DEPARTMENT OF TRANSPORTATION
DIVISION OF ENGINEERING SERVICES
Office of Structural Materials
Quality Assurance and Source Inspection

Contract #: 04-0120F4
Cty: SF/ALA Rte: 80 PM: 13.2/13.9
File #: 69.25B

QUALITY ASSURANCE -- NON-CONFORMANCE REPORT

Reference Description: Improper Joint Fit-up, Poor Weld Quality, Deviation from Shop Drawings, Segment 1AAW

Table 1: PJP Root Openings

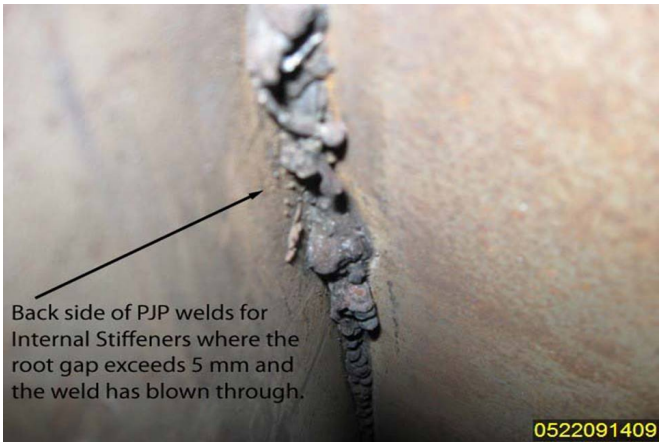
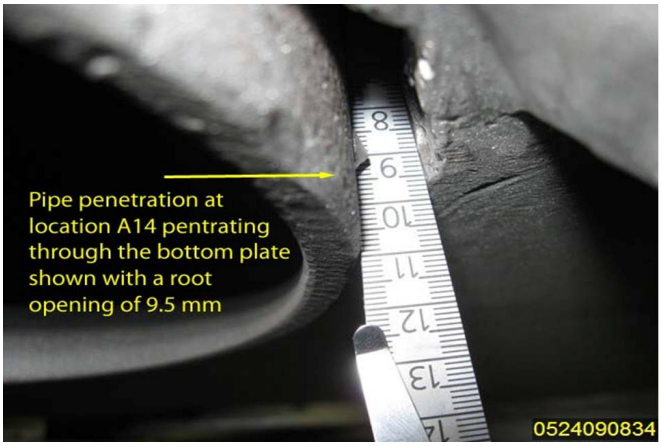
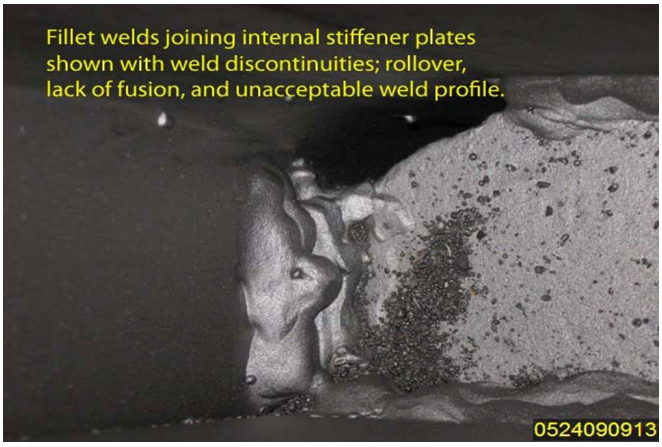
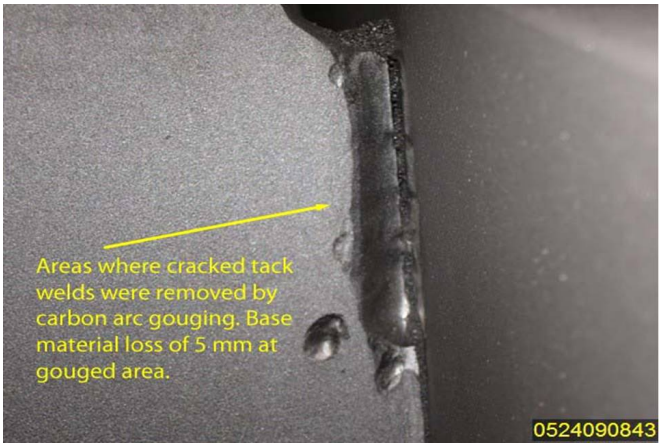
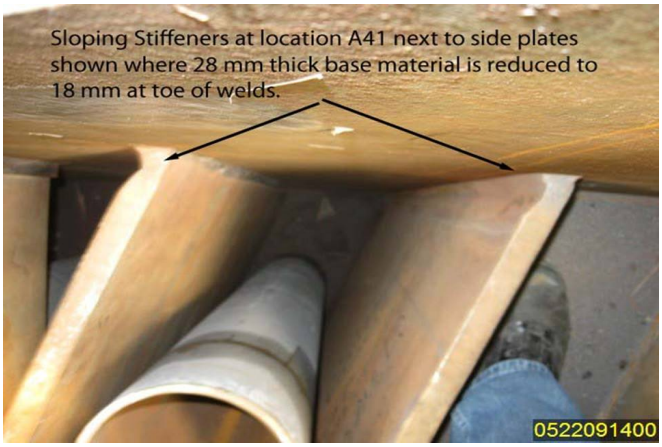
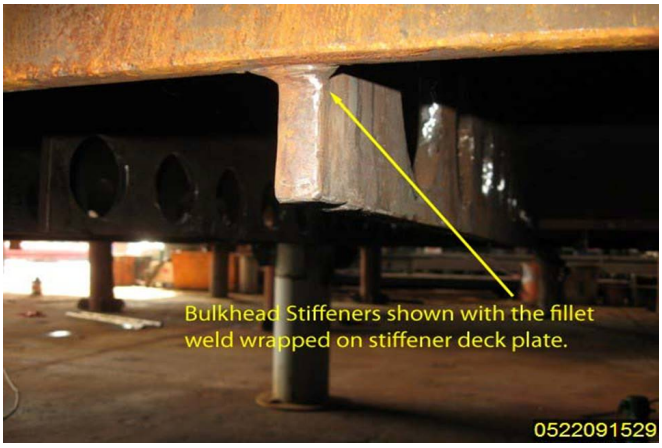
4. Segment internal stiffener Partial Joint Penetration (PJP) Welds have root openings greater than the 5mm allowed per WPS-B-T-2333-Tc-U4b f. See attached table for weld joint numbers and root opening values. The back side of the PJP welds exhibit burn through with slag inclusions which have not been cleaned.

Applicable reference:
AWS D1.5 (02) Section 3.3.2 "The root opening between parts to be joined by PJP groove welds parallel to the member length (bearing joints excepted) shall be zero, or as small as practicable."

ABF has instructed ZPMC to provide the necessary repairs to bring segment 1AAW into compliance with contract requirements. All 8 items are currently being reworked, which includes removal of stiffeners with root gaps exceeding 5mm. ABF issued a stop work order to prevent grouting prior to repair. ZPMC has honored this letter and is in process with repairs. ZPMC has released and fined personnel who were involved in the fabrication and inspection of these segments and held discussions with CWI's on code compliance. ABF has held discussions with our inspectors of preventive action measures to ensure this type of condition does not happen again. ZPMC will provide inspection reports at a later date to close this NCR.

ZPMC	关键焊缝返修报告 Critical Welding Repair Report (CWR)				版本 Rev. No.:
项目名称 Project Name:	美国海湾大桥 SFOBB	部件图号 Drawing No.:	SEG1E	报告编号 Report No.	B-CWR575
合同号 Contract No.:	04-0120F4	部件名称 Item Name:	1AAW	NDT报告编号 Report No.of NDT	NA
项目编号 Project No.:	ZP06-787

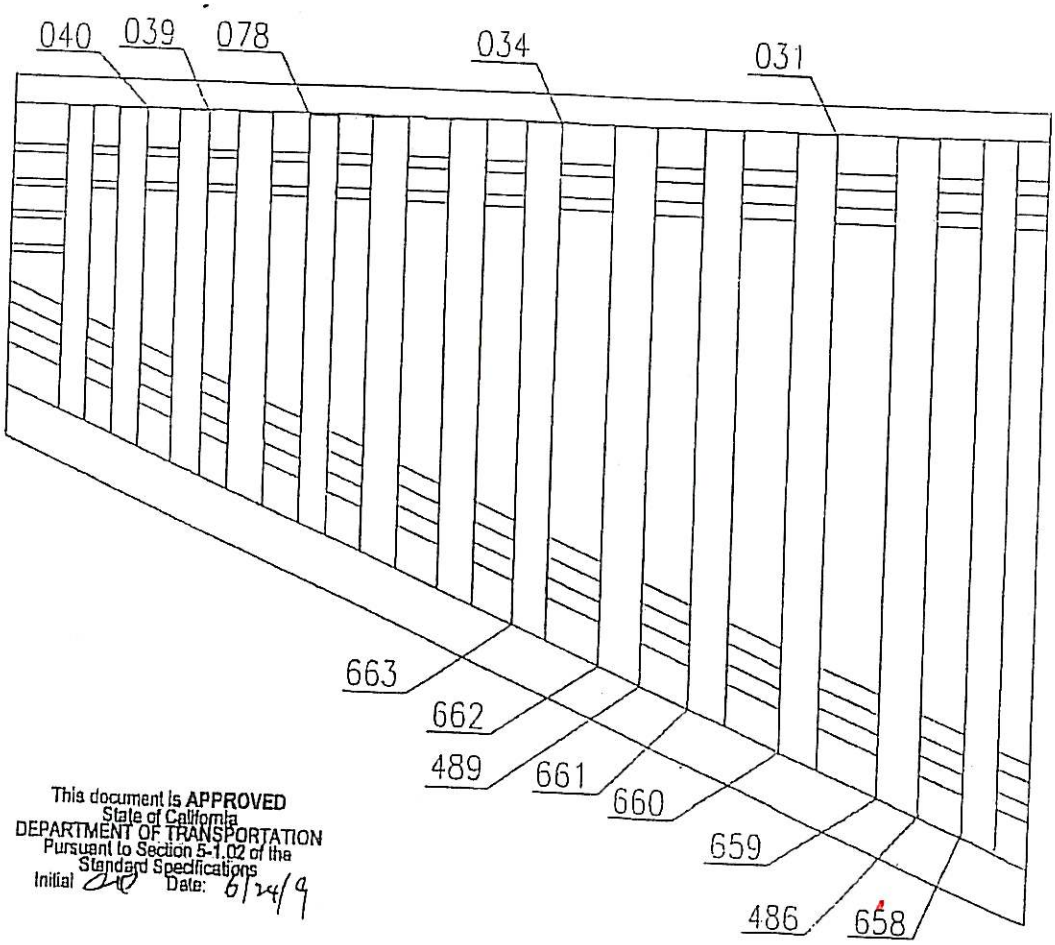
1. Thirteen (13) cracked tacks were found by QA MT Inspector on segment stiffener plates. ZPMC removed the cracked tacks by carbon arc gouging. Plates and stiffener base material will now need to be repaired. The weld numbers are as follows; Seg1E-031, 034, 039, 040, 078, 486, 489, 658, 659, 660, 661, 662, and 663.

1) The crack on tack weld had been removed and repaired the base material with B-CWR575, please check the CWR and the NDT report.
2) The ABF-RI-1778 is approved and ZPMC had kept the wrapped.
3) According to the RFI-ZPM-702 and the B-WR5642, ZPMC had corrected the locations where the gap exceeded 2mm.
4) Please find the attachment about the internal stiffener repairing plans, the gap had been corrected and the welds had been verified NDT by ZPMC and CT.
5) The welds had been repaired by grinding, the NDT report is here.
6) The same to the item 4.
7) The location had been repaired by grinding and NDT verified onsite.
8) The pipe at this location had been replaced, the B-WR5443 is here.
9) The wrong weld ID is here, actually the right weld ID is SEG1E-584 and the steel backing bar had been removed, and the UT had been confirmed.

Subject: Fabrication Issue: Root Gap of PJP between End Stiffener and Strand Stiffener
References:
Response required by: 2009-6- 17(date) Response affects critical path activity? X YES ____ NO

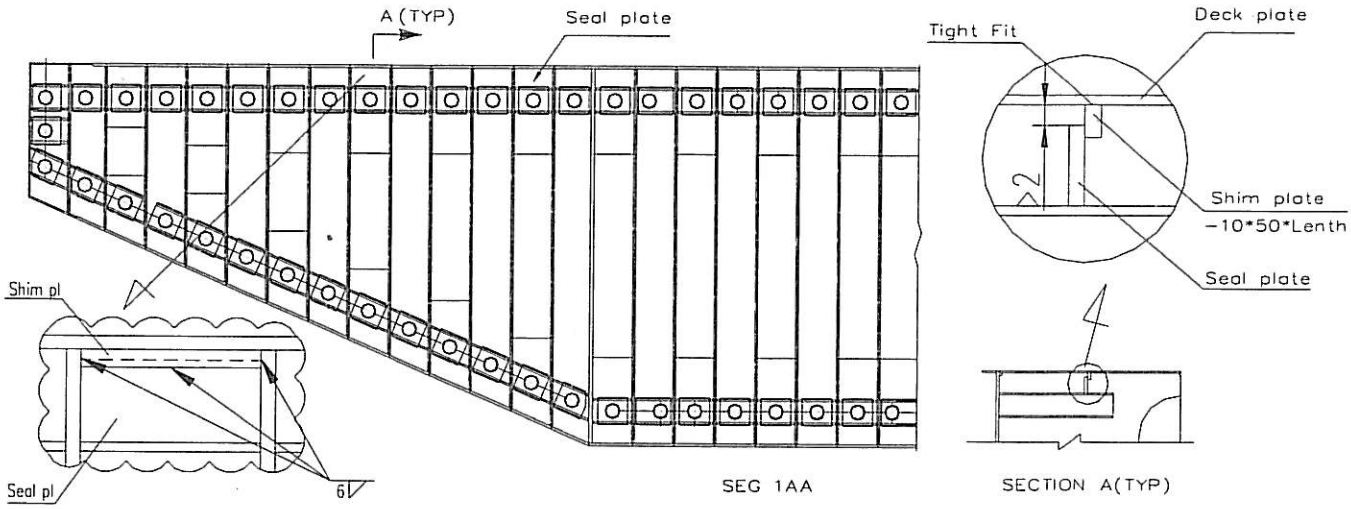
During fabrication of 1AA, in the drawings of SEG1C, SEG1D, SEG2C, SEG2D, it should be tight fit between seal plates and deck plate, but shop workers missed the requirements when fitting. That leaded to excessive fit-up gap. For the fit-up gap >2mm, we propose to add a shim plate (A709M-345T2) tight fit to deck plates (no weld, sealed with silicone). The shim plates will be 6mm fillet welded with the seal plates and end stiffeners. For details, see the following fig.

项目名称 Project Name	美国海湾大桥 SFOBB	部件图号 Drawing No	SEG1/2	报告编号 Report No.	B-WR5642
合同号 Contract No.:	04-0120F4	部件名称 Items Name	OBG FLOOR BEAM	NDT报告编号 Report No.of NDT	NA
项目编号 Project No.:	ZP06-787

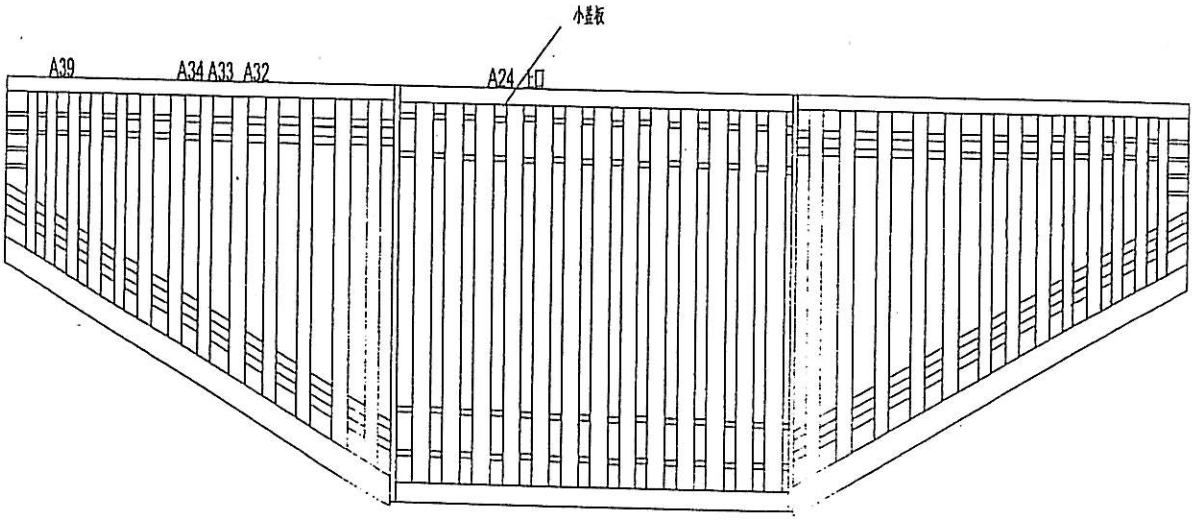
1AAW,1AAE两个箱体顶板位置图纸上（小盖板）不允许烧焊，现场原烧焊又割掉，现去除小盖板。

1. Remove the seal plates by heat cutting or gouging, note not to gouge base metal.
2. Remove all defects and grind the area flush to base metal.
3. Perform MT of this area.
4. Re-assemble seal plates tight fit to deck plates..
